Exhibit A

Revised Plans, dated August 22, 2014, prepared by Shalom Baranes Associates

**DISTRICT OF COLUMBIA
A PLANNED UNIT DEVELOPMENT**

MODIFICATION TO A CONSOLIDATED PLANNED UNIT
DEVELOPMENT APPROVED PURSUANT TO ZONING
COMMISSION CASE NO. 07-26

APPROVED PUD ELEVATION

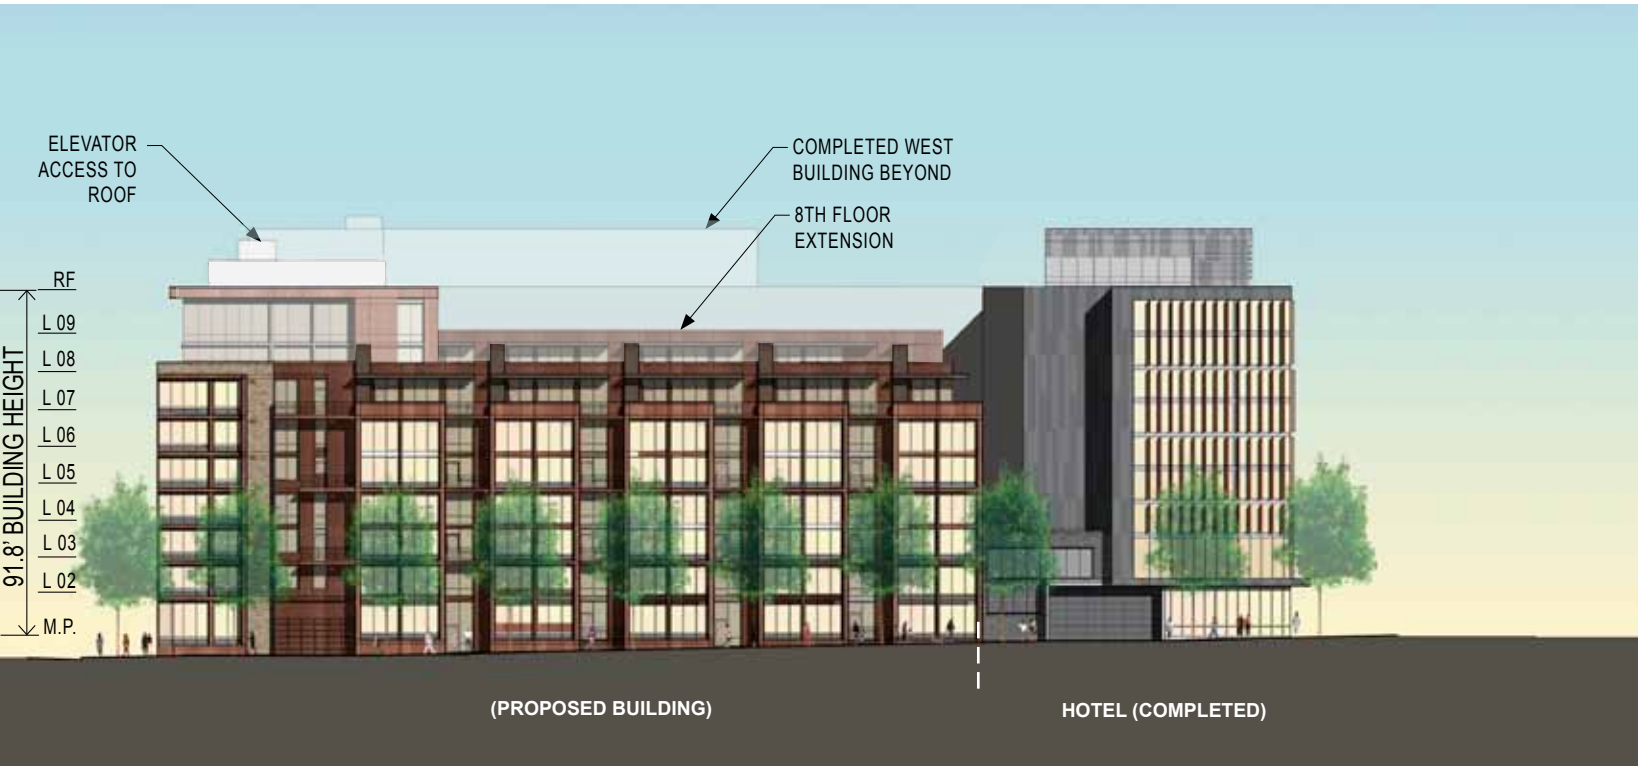
NO ELEVATOR ACCESS TO THE ROOF
IN THE APPROVED ROOF PLAN (SEE
PAGE A.08).

NEW ELEVATOR PROVIDES FOR ADA
ACCESS TO THE ROOF.

APPROVED NON COMPLIANT ROOF STRUCTURE SETBACK

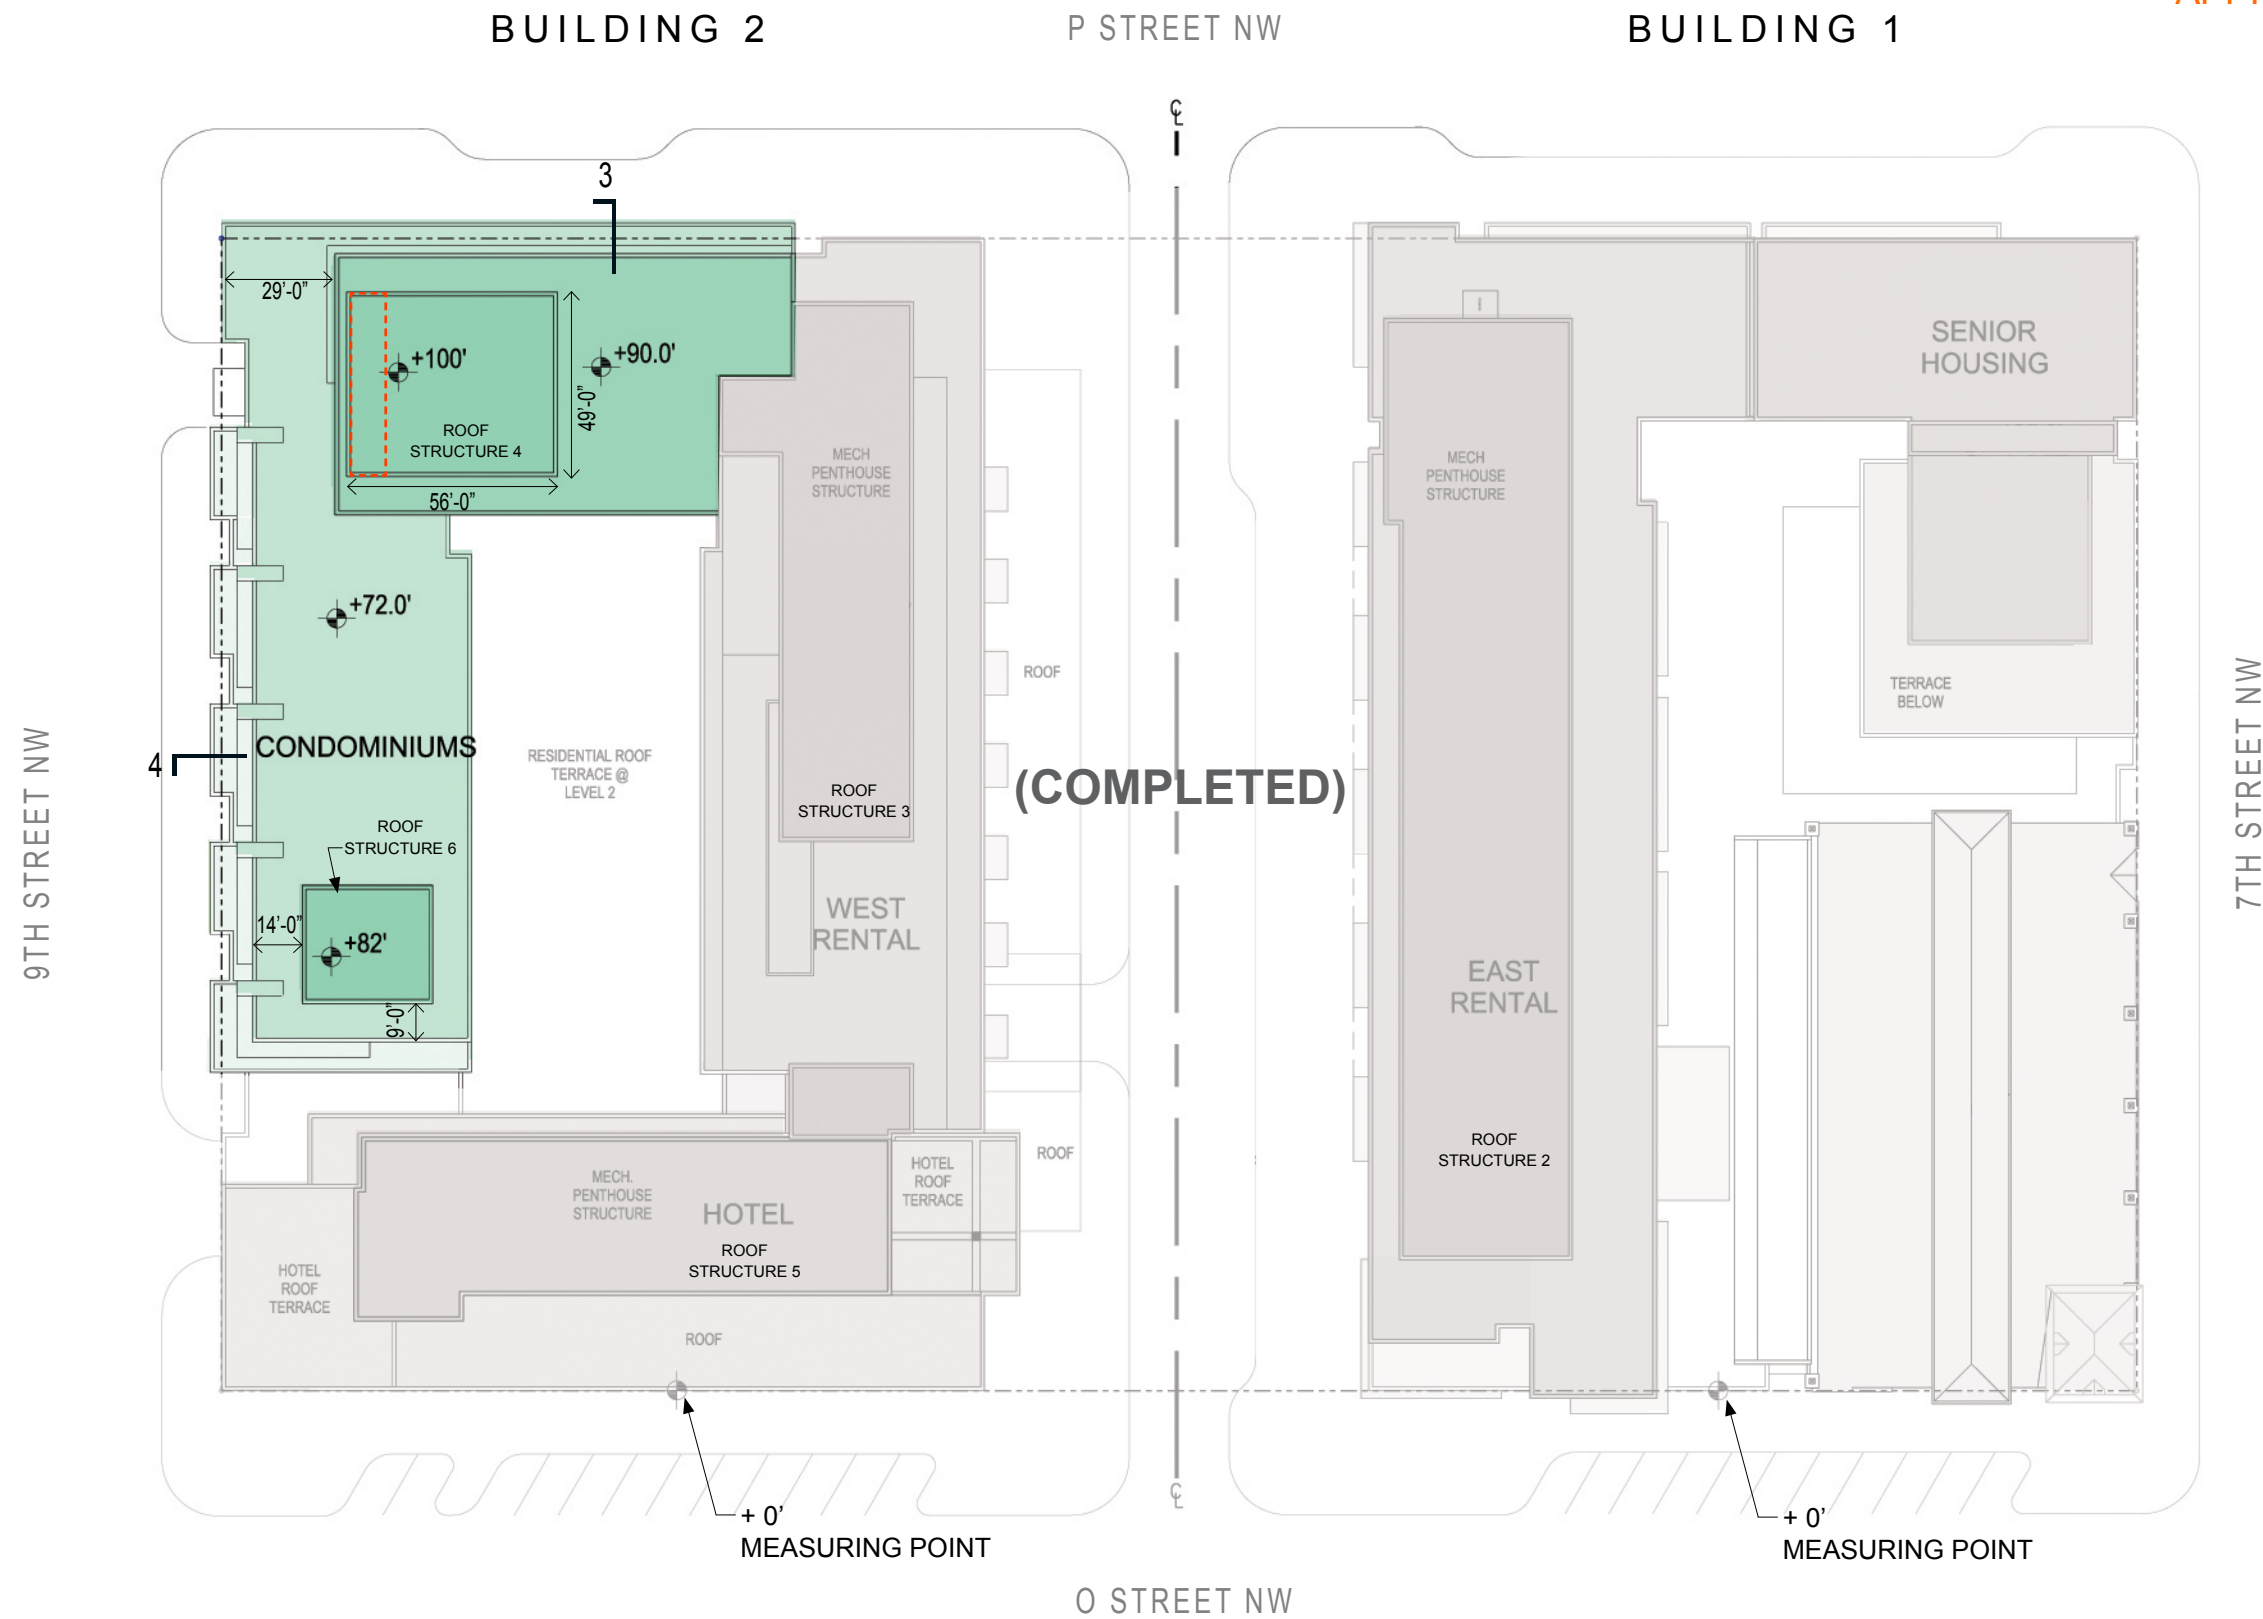
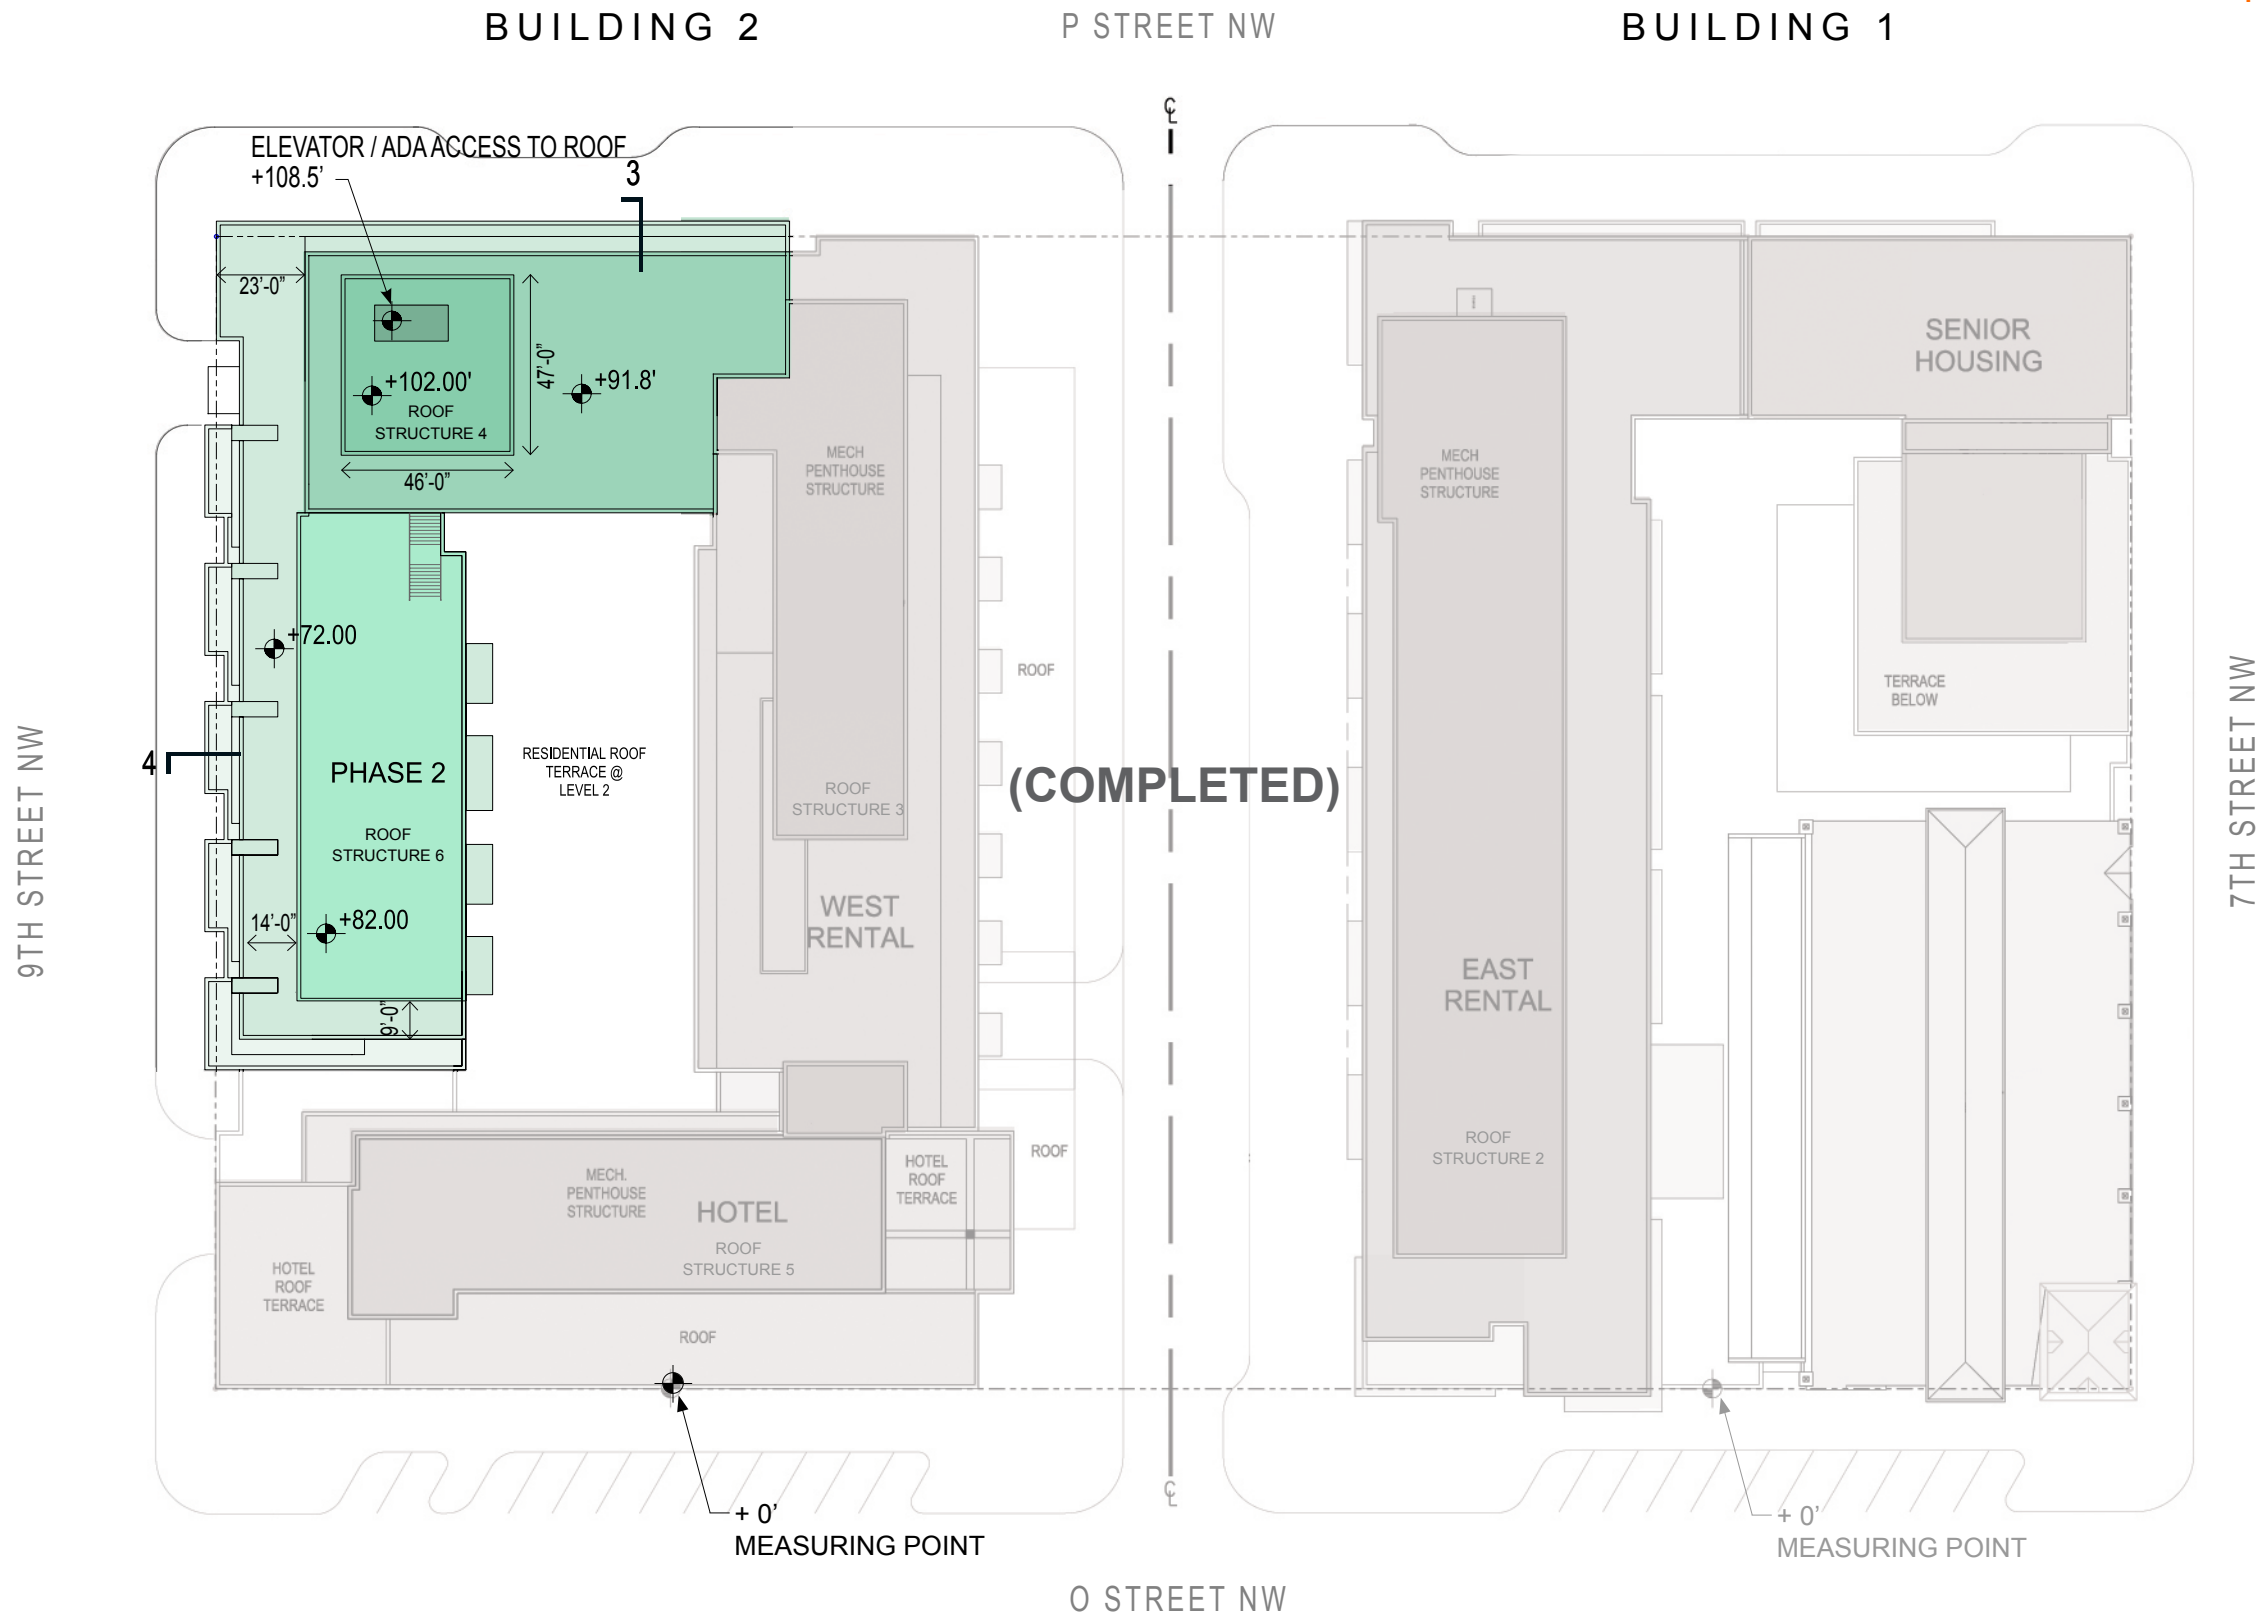
NON COMPLIANT ROOF
STRUCTURE SETBACK ELIMINATED

IN RESPONSE TO THE ZONING COMMISSION'S COMMENTS AT THE SETDOWN HEARING OF JUNE 26TH 2014, THE DESIGN OF THE PROPOSED ROOF STRUCTURE 4 AND ELEVATOR CORE LOCATION HAS BEEN MODIFIED TO ALLOW FOR THE 1:1 SETBACK REQUIREMENT TO BE MET. ROOF STRUCTURE 4 AND THE PROPOSED ELEVATOR POP UP HAS BEEN MODIFIED SO THAT THE ENTIRE ROOF STRUCTURE IS NOW COMPLIANT WITH THE 1:1 ZONING SETBACK MAKING THE ROOF STRUCTURE LESS NOTICEABLE FROM PUBLIC VIEW THAN IN THE ORIGINALLY APPROVED PUD. ENABLING THE ELEVATORS, LOCATED AT THE NORTH WEST CORNER OF THE BUILDING TO RUN UP TO THE ROOF WILL ALLOW FOR RESIDENT ACCESS AND THE NECESSARY ADA ACCESSIBILITY TO THE PLANNED ROOFTOP AMENITIES.

PROPOSED PUD WALL SECTIONS

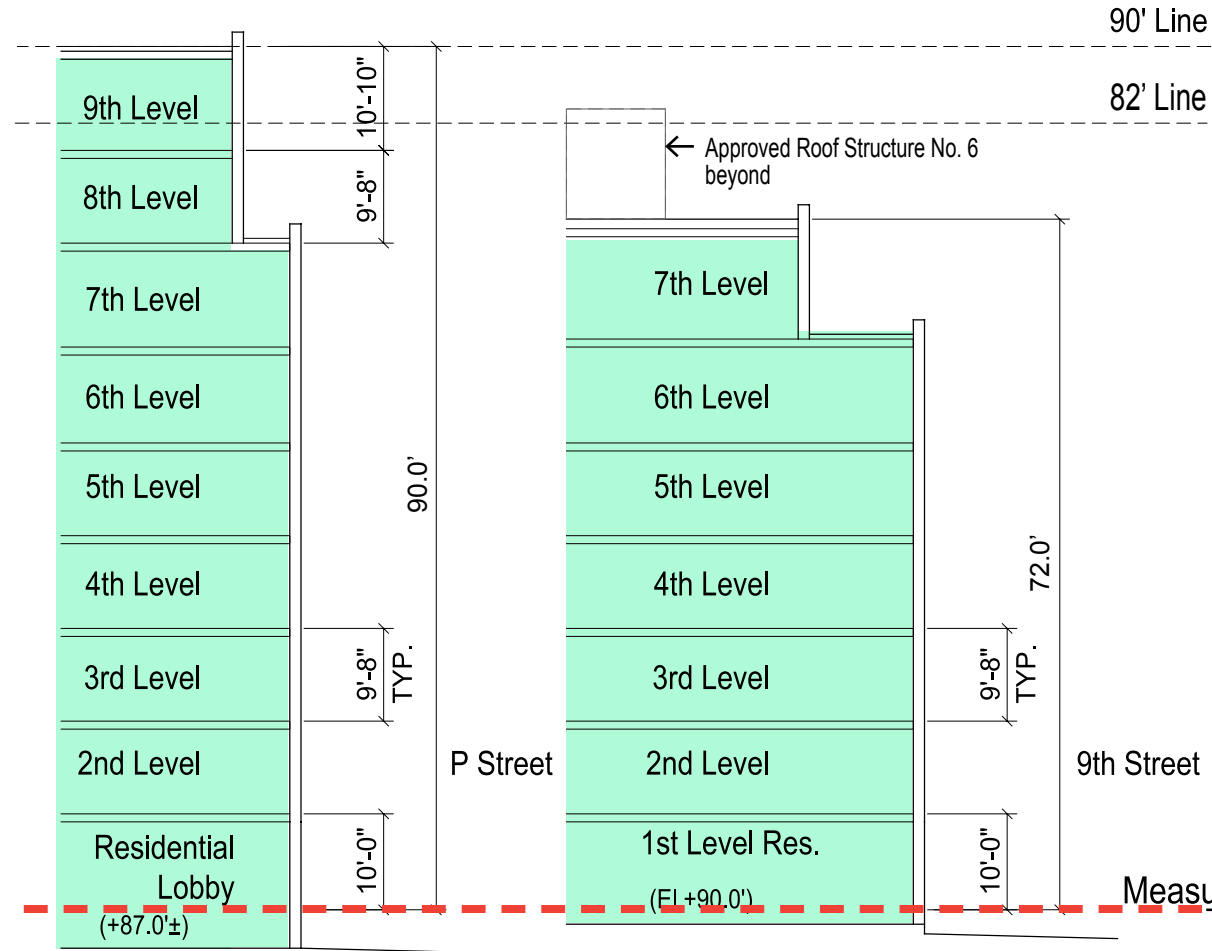
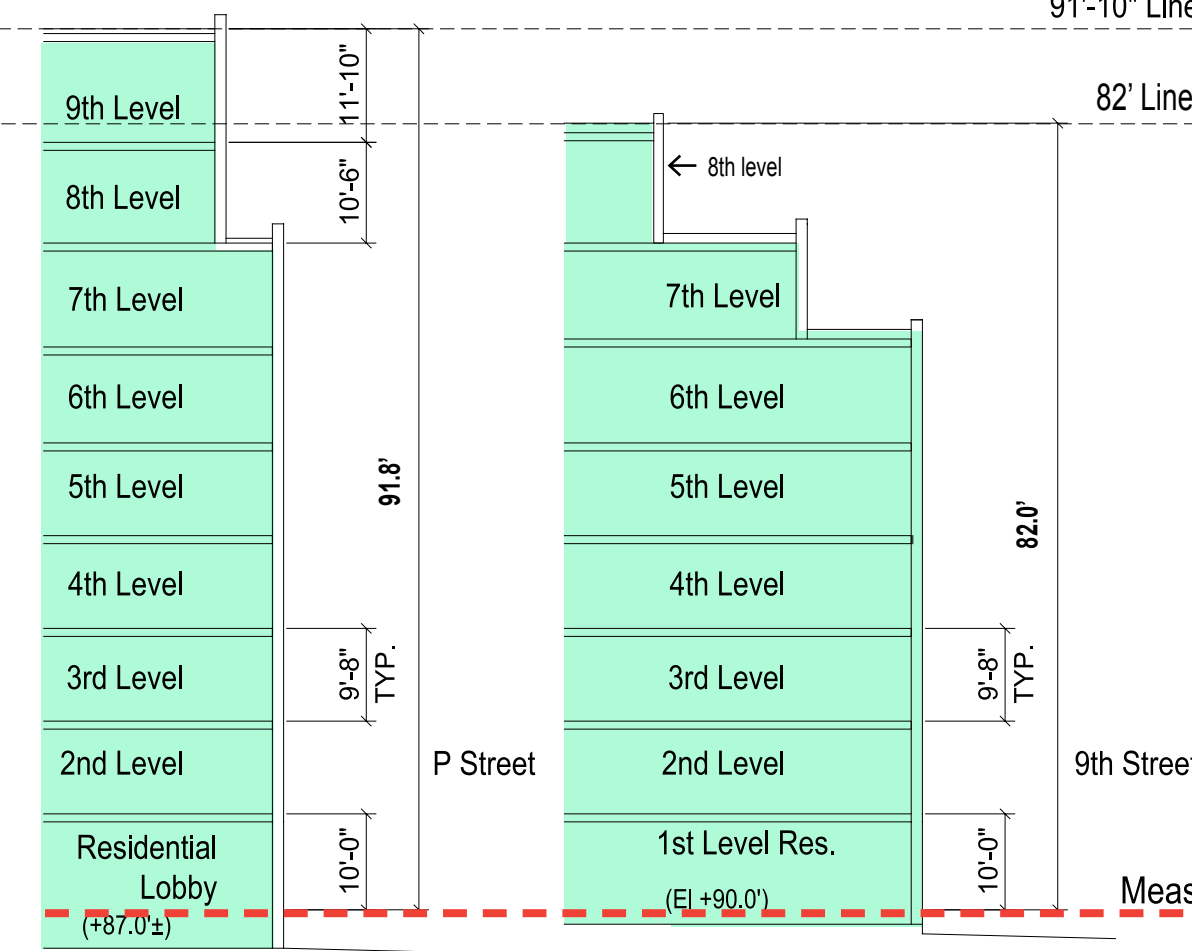
91'-10" Line
